To: Bill Gamlen, SMART
From: Luke Evans, AECOM
File No: Sonoma-Marin Area Rail Transit Non-Motorized Pathway Phase 1 Project
From McInnis Parkway in San Rafael, California (SMART MP 20.1) to
Guerneville Road in Santa Rosa, California (SMART MP 55.3)
Federal Aid Project # RPSTPLE 6411 (005)
Date: August 28, 2015
Subject: Revised Wetlands Only Practicable Alternative Finding Memorandum. Pursuant to Executive
Order 11990 – Protection of Wetlands.

**TABLE AND MAPS SHOWING REFINEMENTS MADE TO THE BUILD ALTERNATIVE BY SEGMENT TO AVOID
WETLANDS**

**SMART NMP
Wetlands Map**
Map Sheet 80

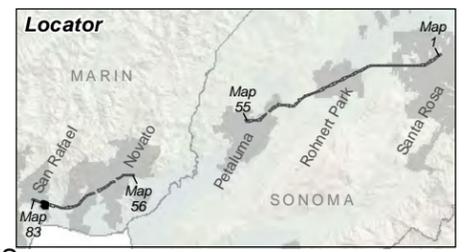
5. Map Sheet 80: LGVSD has force main crossings at the old Smith Ranch Road and near the current Smith Ranch Road. Force mains and valves are located on both sides of the tracks. LGVSD should have emergency vehicle access on the pathway from Miller Creek to Smith Ranch Road.

**SMART NMP
Wetlands Map**
Map Sheet 81

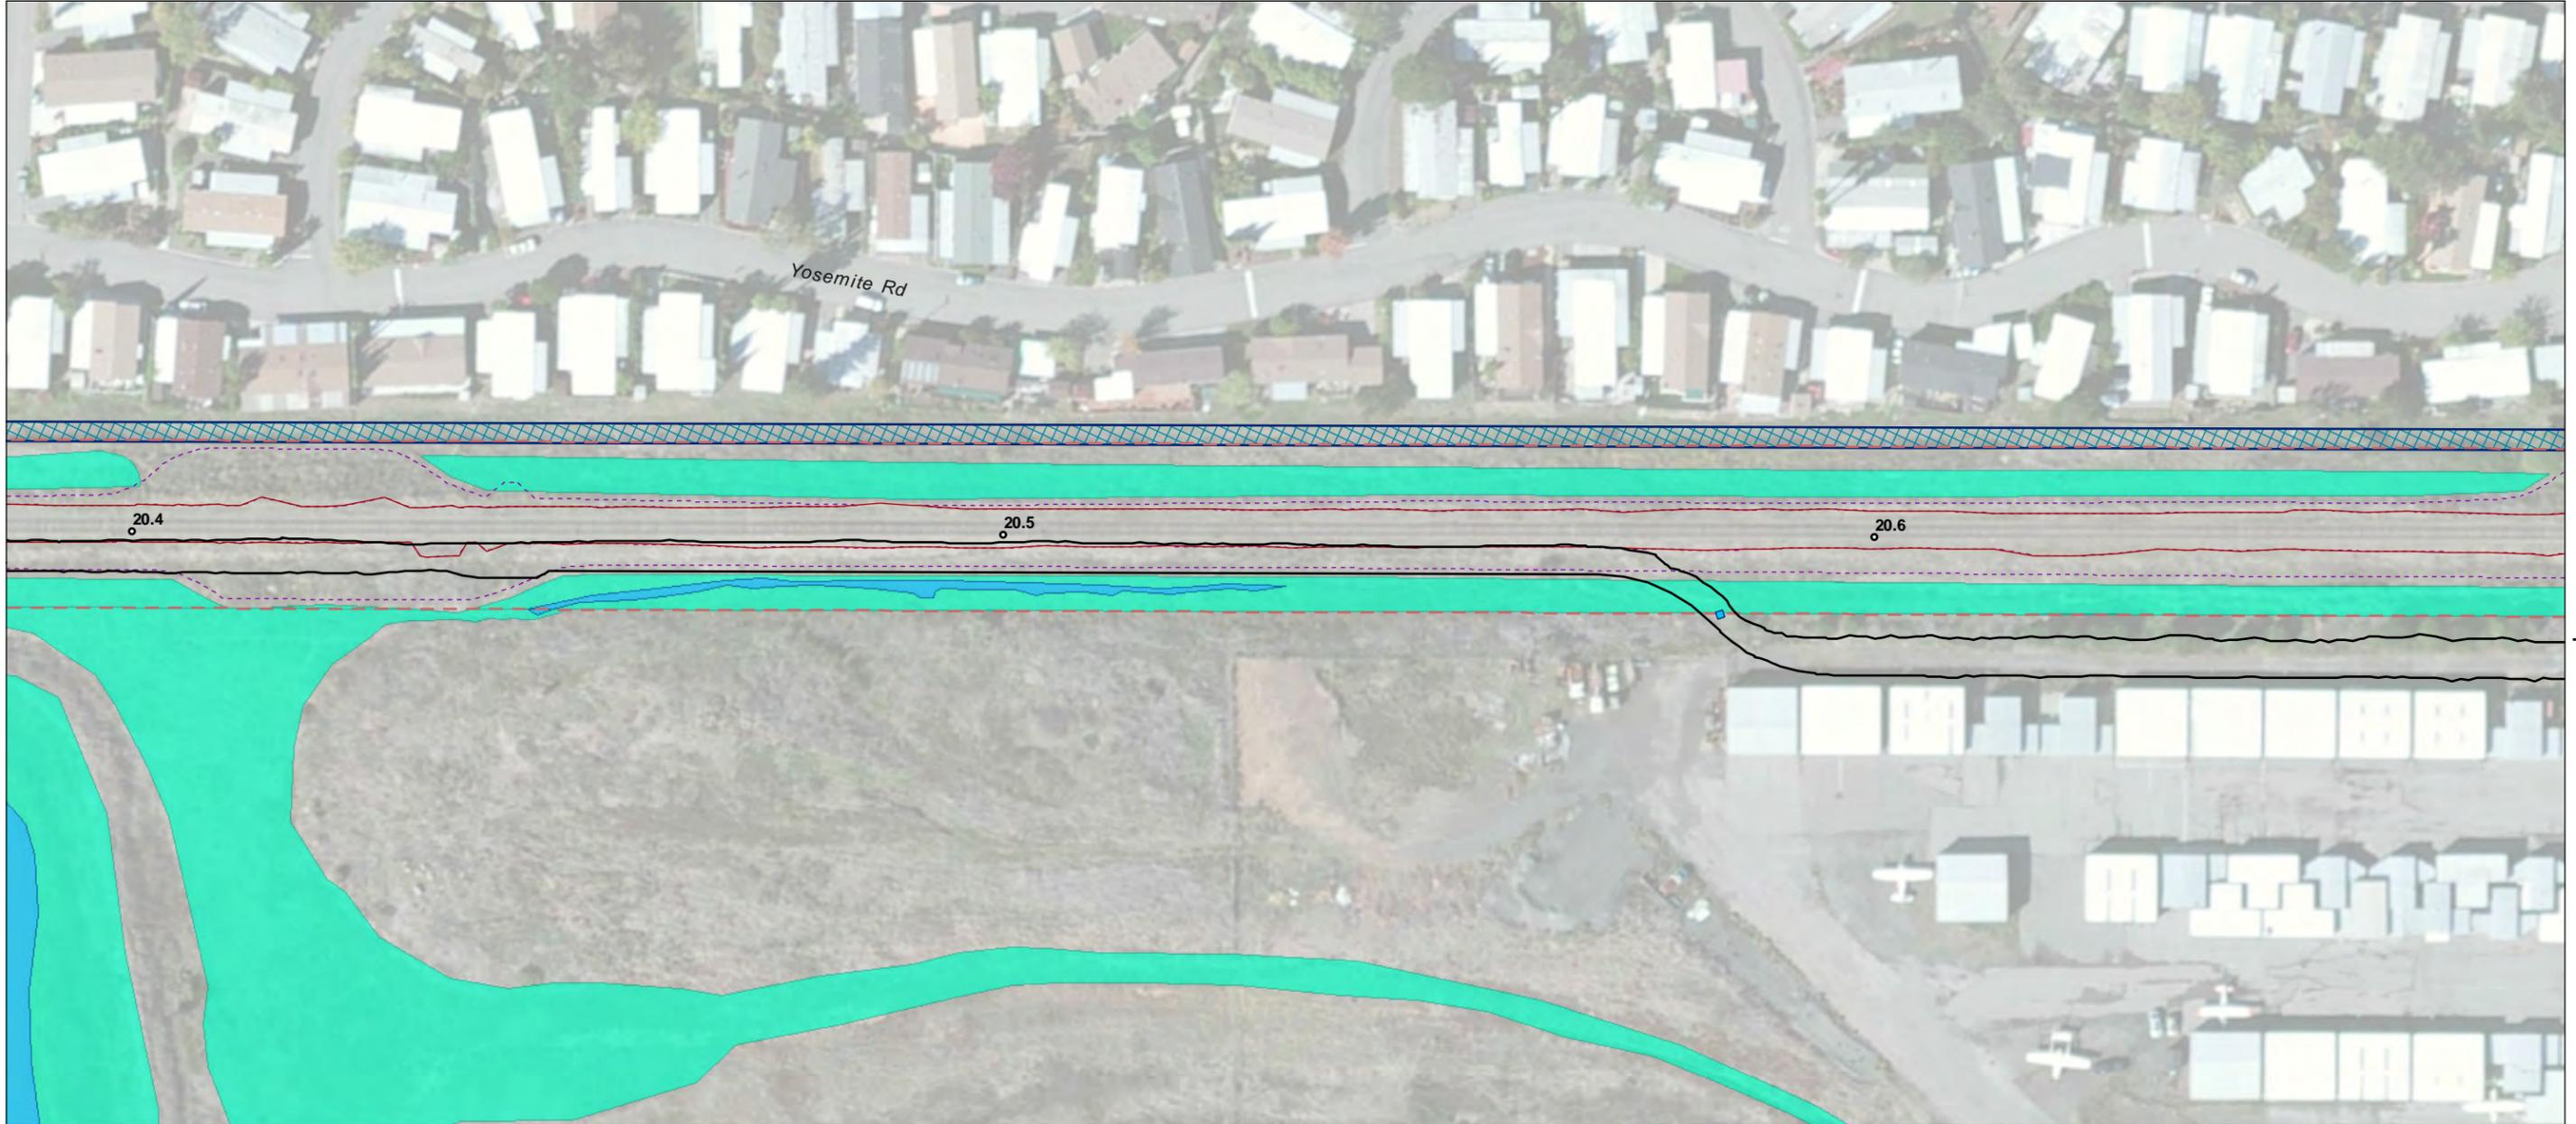
6. Map Sheet 81: LGVSD has force mains and valves located on the easterly side of the SMART ROW. The proposed pathway looks like it will be located on the Airport property over LGVSD force mains and will be in existing LGVSD easements. LGVSD should have emergency vehicle access on this pathway from the Airport to McInnis Parkway.
